Application No. A/NE-TKL/837

Section 16 Planning Application for Temporary Open Storage of Recycling Materials and Metalware with Ancillary Facilities and Associated Filling of Land for a Period of 3 Years at Lots 86 (Part), 87 and 89 in D.D. 83 and Adjoining Government Land, Kwan Tei North, Fanling, New Territories

Submission of Further Information 2

Responses to Departmental Comments

11m Heavy Goods Vehicle
Overall Length 11.000m
Overall Width 2.500m
Overall Body Height 3.632m
Min Body Ground Clearance 0.427m
Track Width 2.500m
Lock-to-lock time 6.00s
Curb to Curb Turning Radius 11.000m

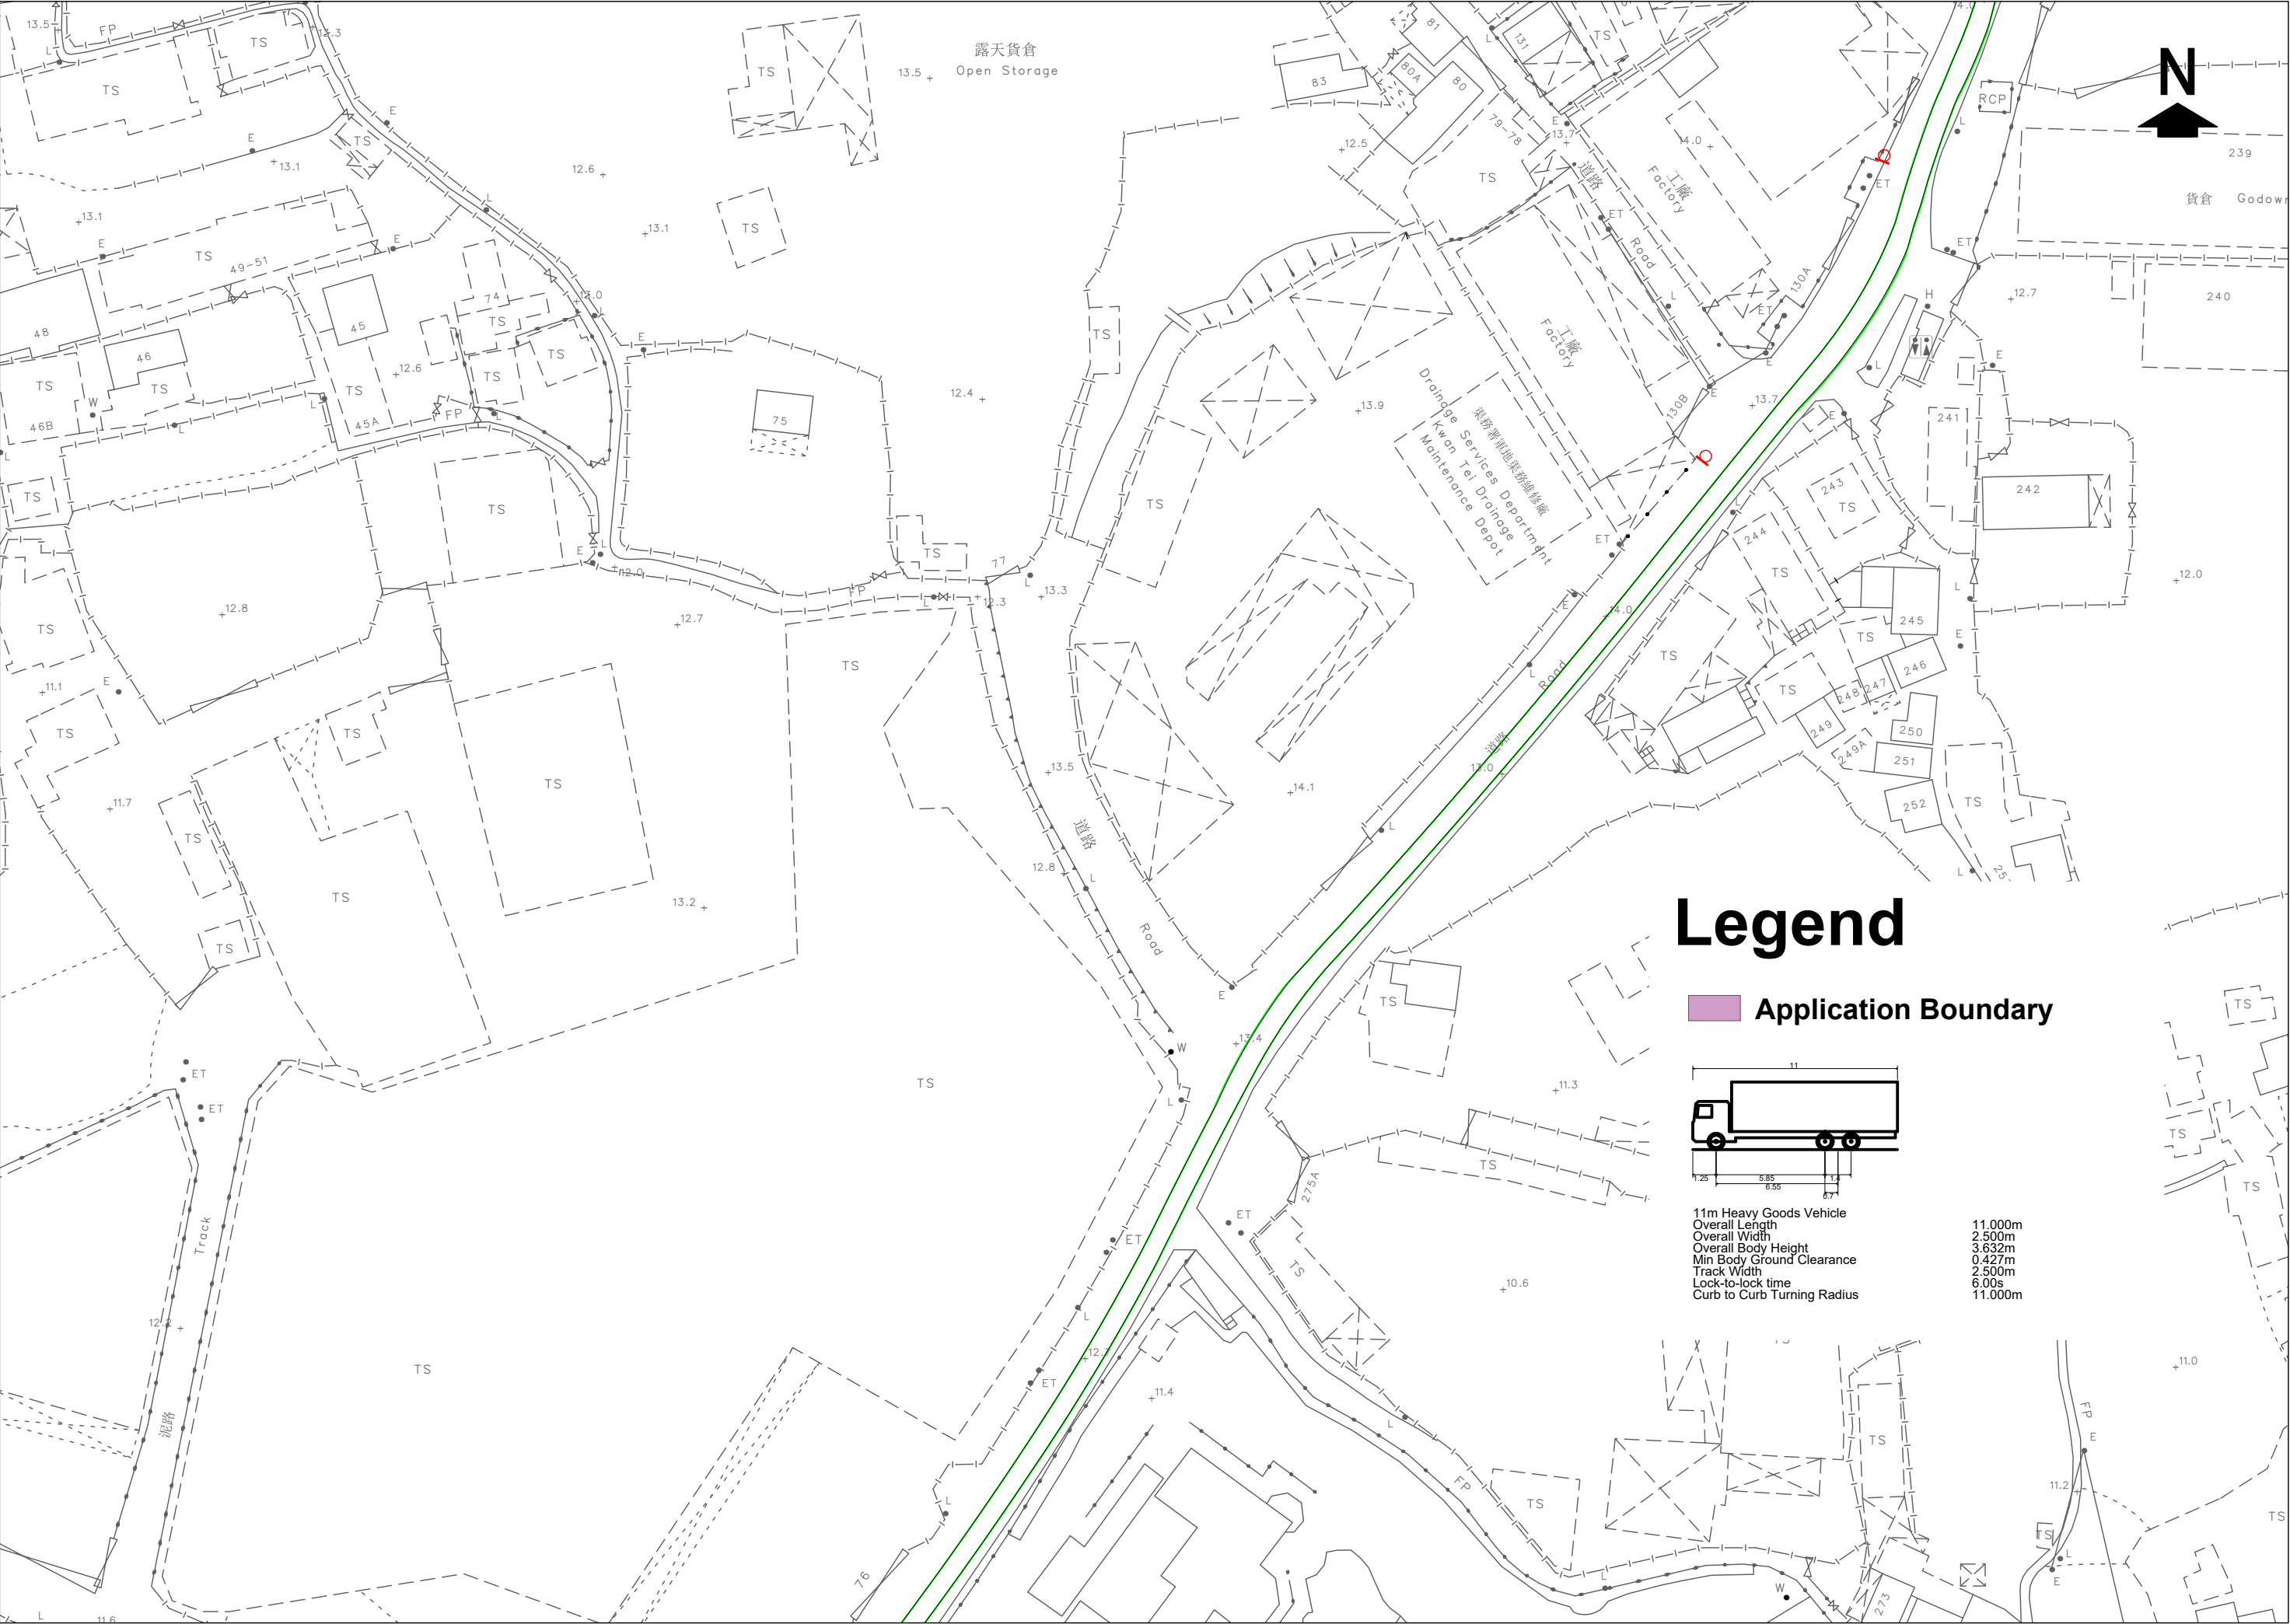
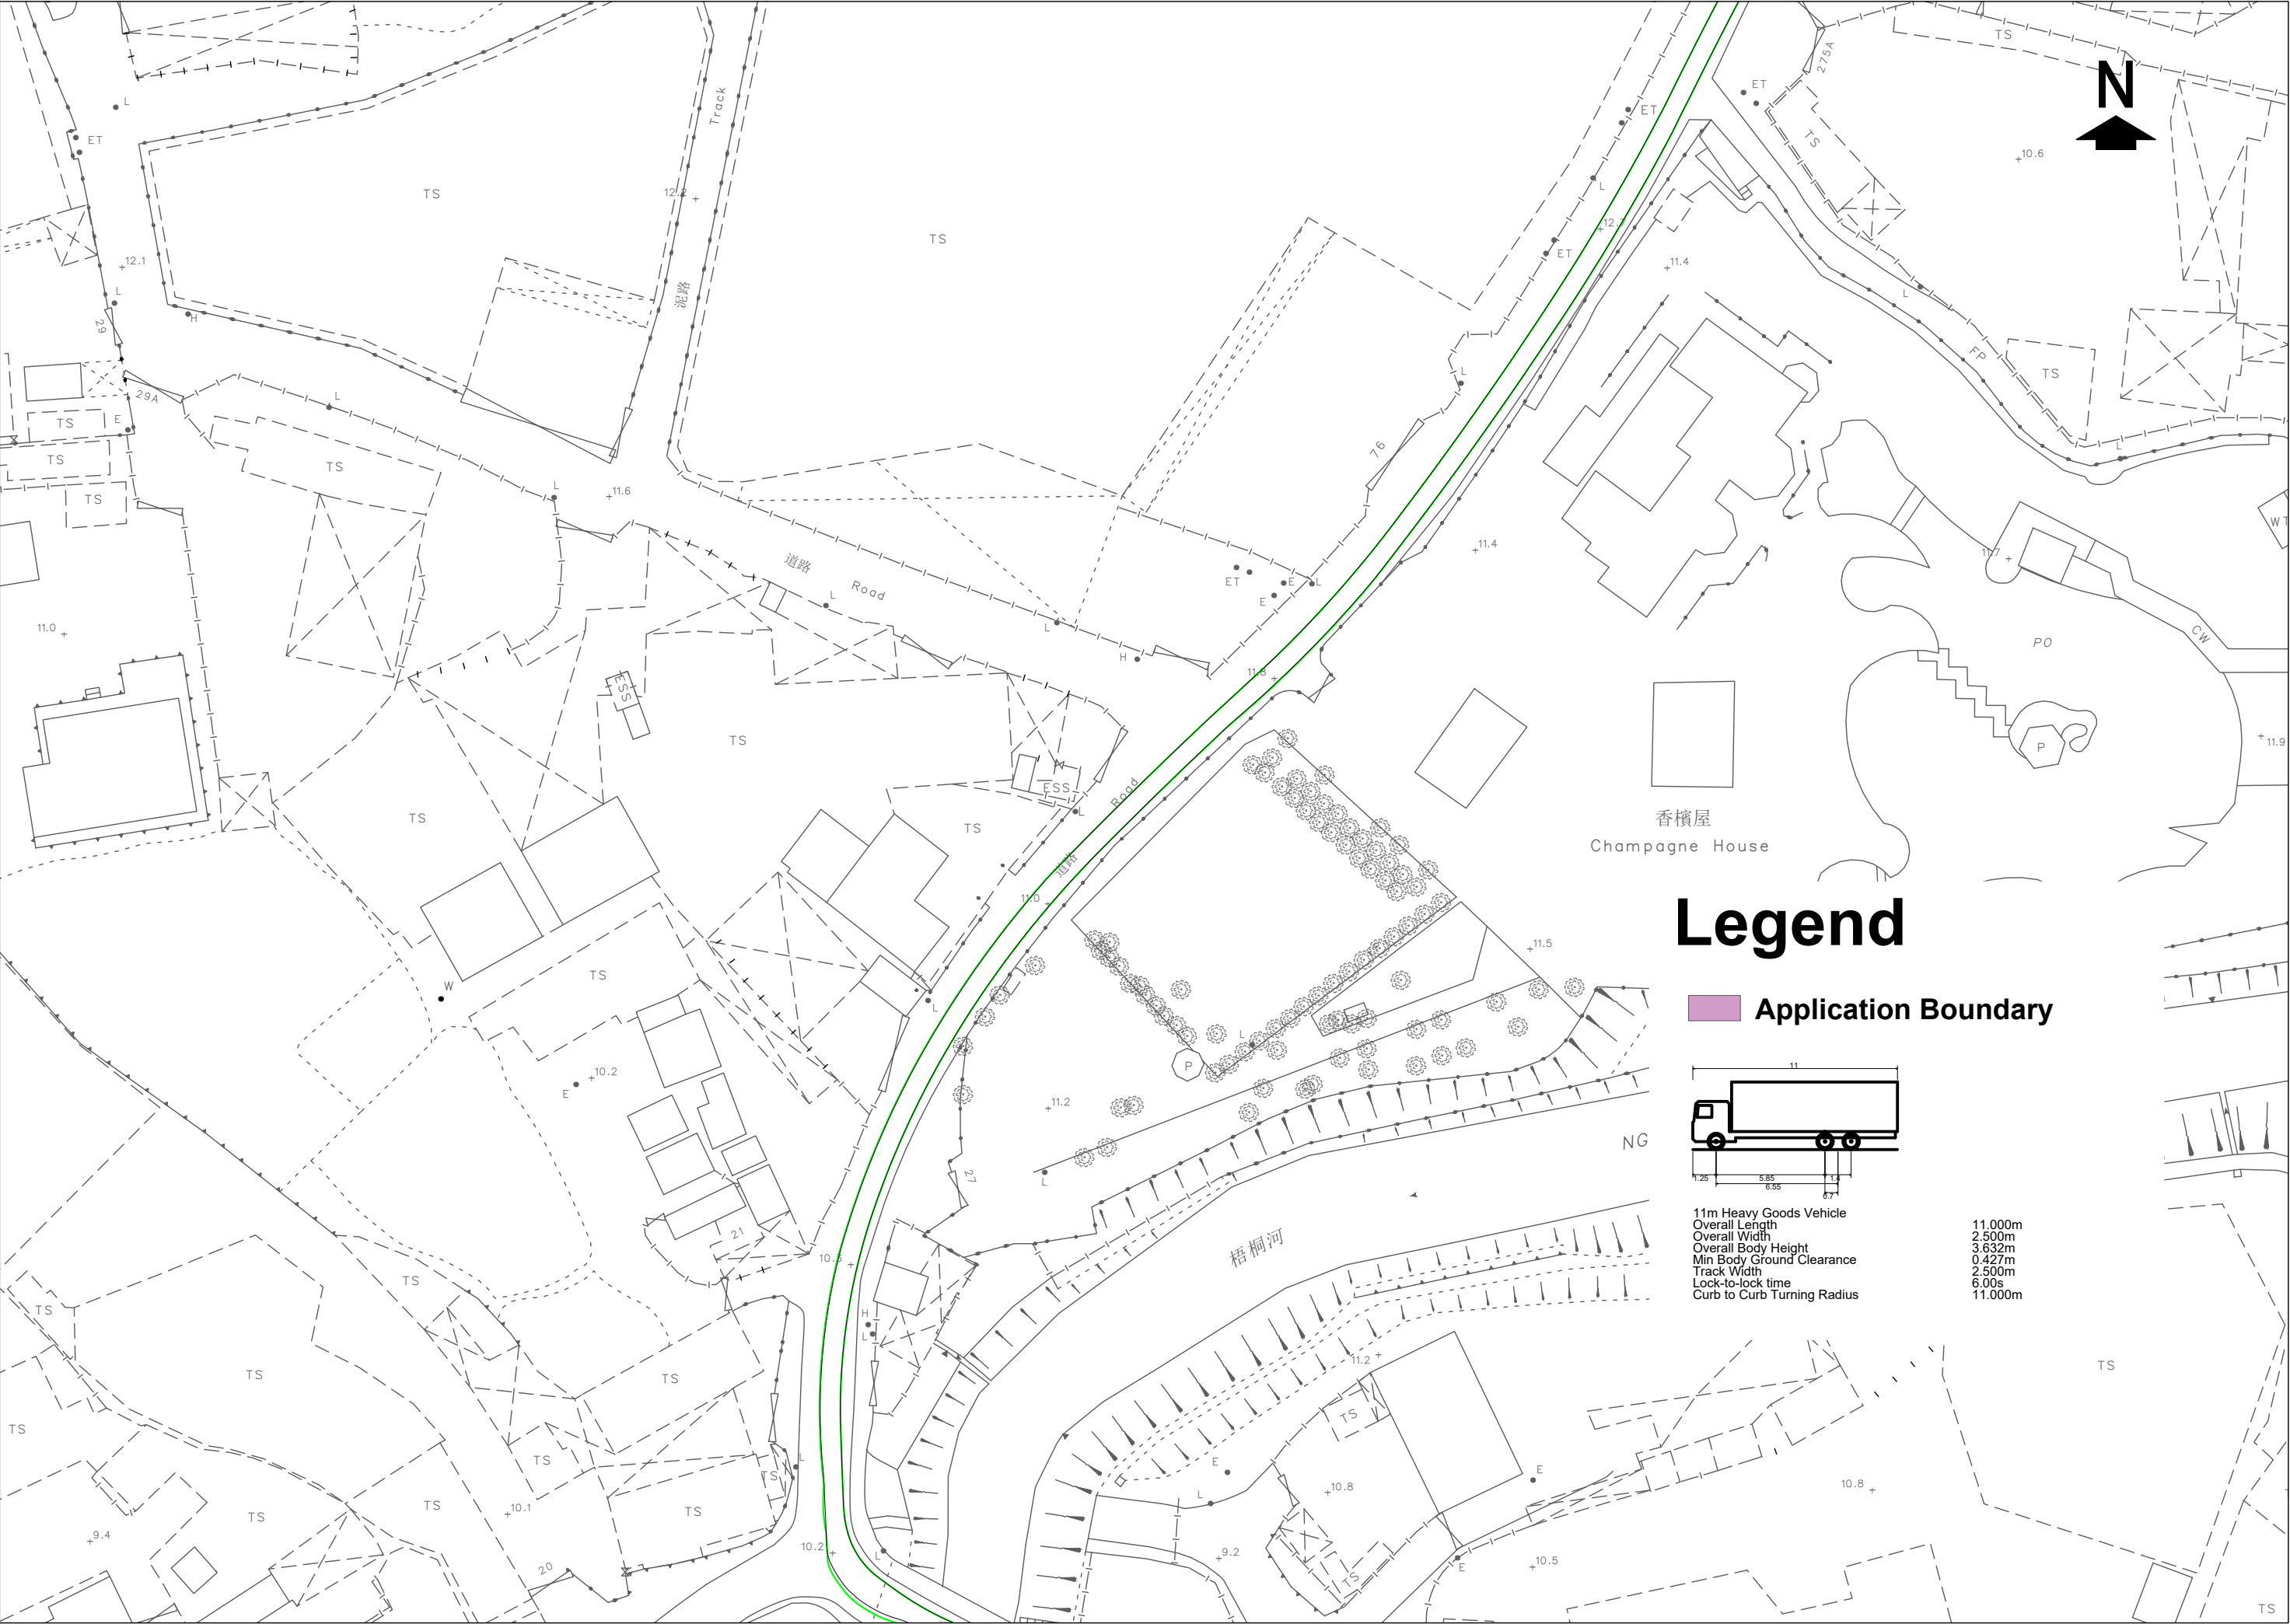
Item	Departmental Comments	Applicant's Responses
1. Comments from Transport Department received on 18.5.2026		
	- the dimension of good vehicles used for swept path analysis should follow the table 5.4.4.1 in Volume 7 of TPDM; and - the applicant should propose measures, such as installation of traffic warning signs and provision of passing bays, to ensure that the movement of site vehicles will not clash with the vehicles riding in opposite direction along the access road linking Sha Tau Kok Road - Lung Yuek Tau to the application site.	The revised swept path analysis is attached at Annex 1 of this FI submission. Please refer to Annex 2 for the proposed traffic warning signs along the access road, which are located on Government land. Upon approval of the application, the Applicant will apply to the relevant departments for permission for the installation of the signage.
